Proposal for Correction to ECE/TRANS/WP.29/GRE/2013/49

The text reproduced below was prepared by the expert from The International Automotive Lighting and Light Signalling Expert Group (GTB) to correct editorial mistakes that have been identified since the submission of the formal document. The corrections to the text of the original proposal are identified by comments in the right-hand column.

"Figure 1

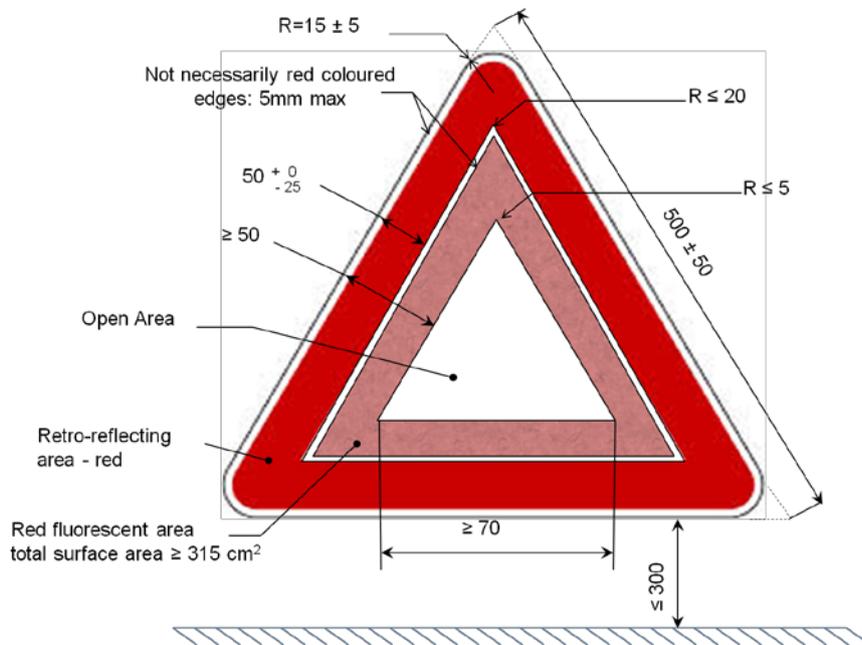
Annex 3, figure 1., amend to read:

Comment [GTB2]: This figure replaces the figure in GRE/2013/49 and is based upon a PPT file that is provided separately to the secretariat to allow editing for translation.
